# CONSTRUCTION DOCUMENTS MAYBERRY, COLORADO - FILING NO. 4

BEING A REPLAT OF TRACT A, MAYBERRY, COLORADO SPRINGS FILING NO. 3  
LYING THE NORTHEAST QUARTER OF SECTION 14, TOWNSHIP 14 SOUTH, RANGE 63 WEST OF THE 6TH PRINCIPAL MERIDIAN  
COUNTY OF EL PASO (UNINCORPORATED), STATE OF COLORADO

PCD FILE NO. SF2317

WATER LINE A  
PLAN & PROFILE

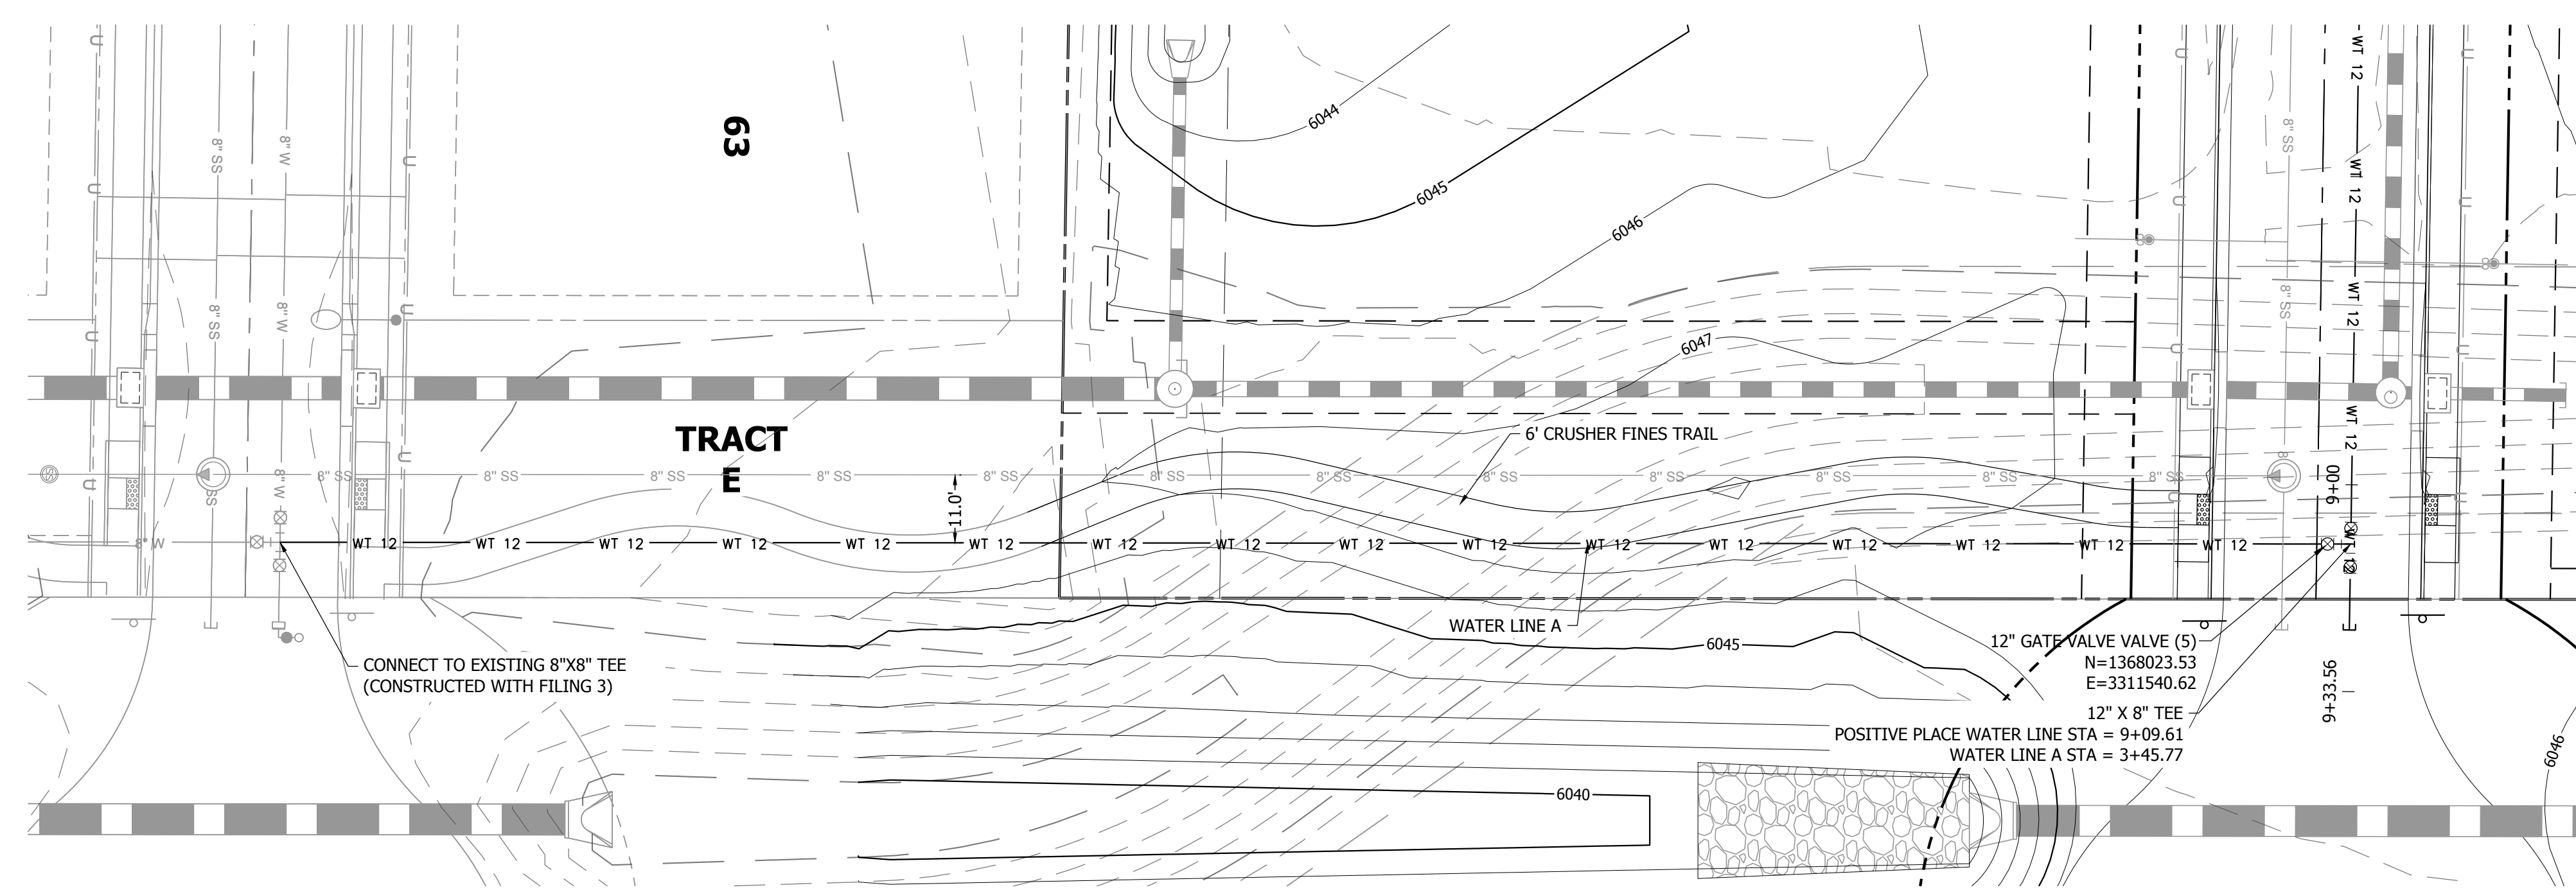
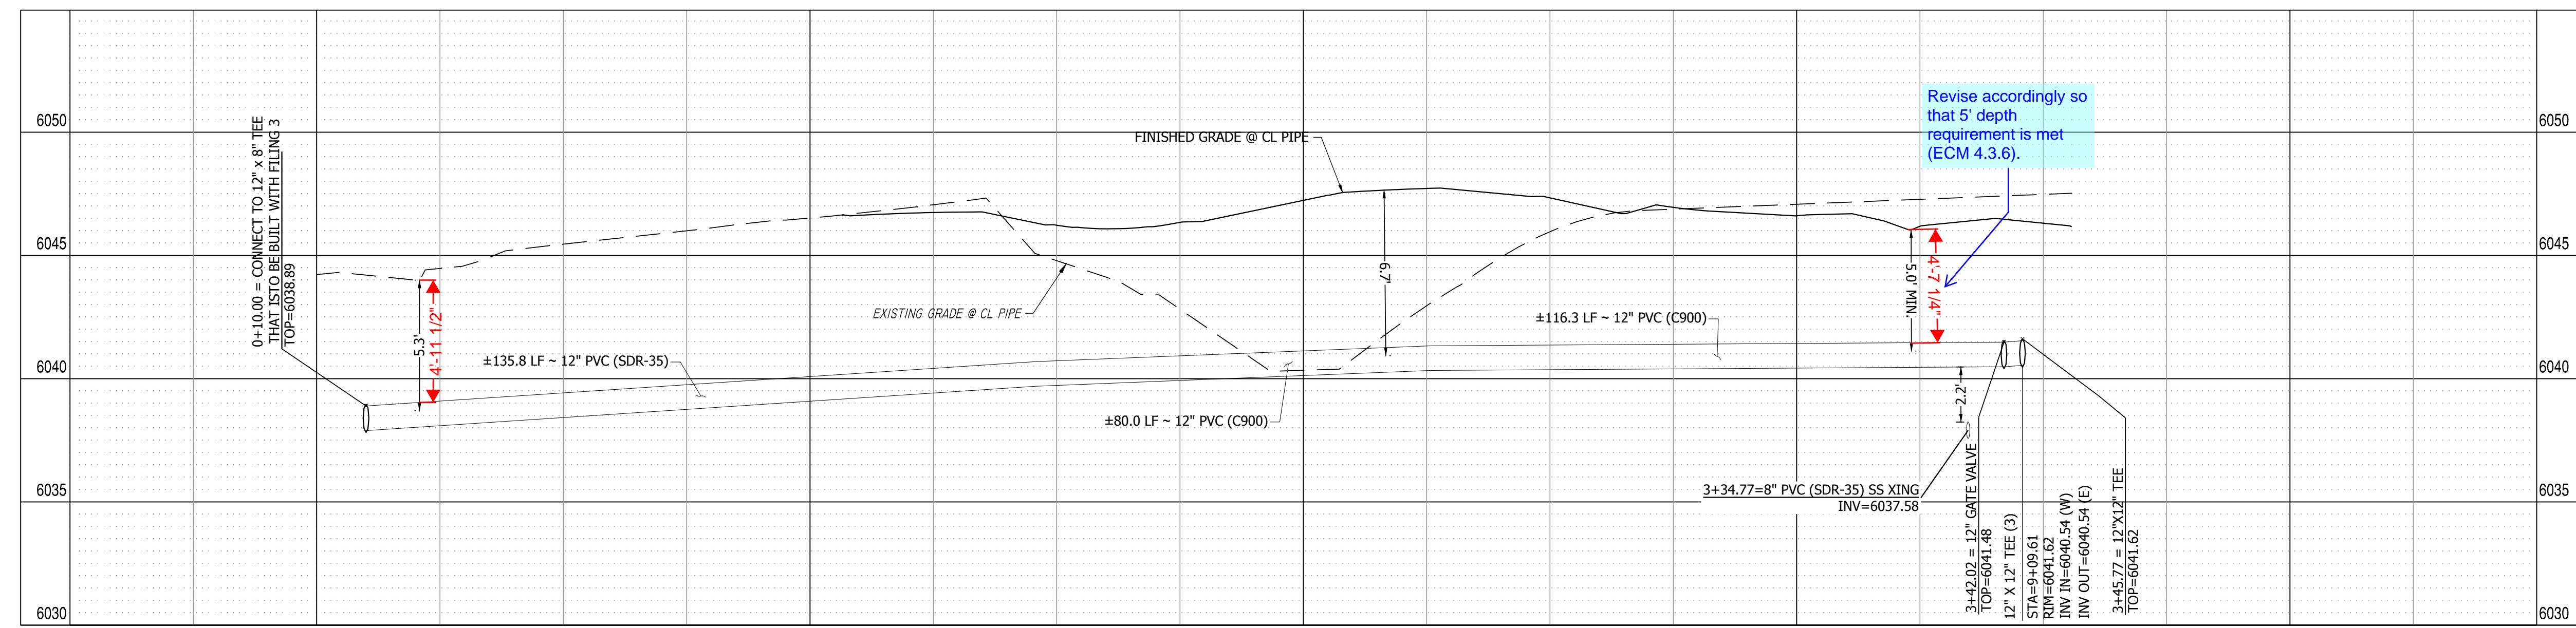
Revise accordingly so that 5' depth requirement is met (ECM 4.3.6).
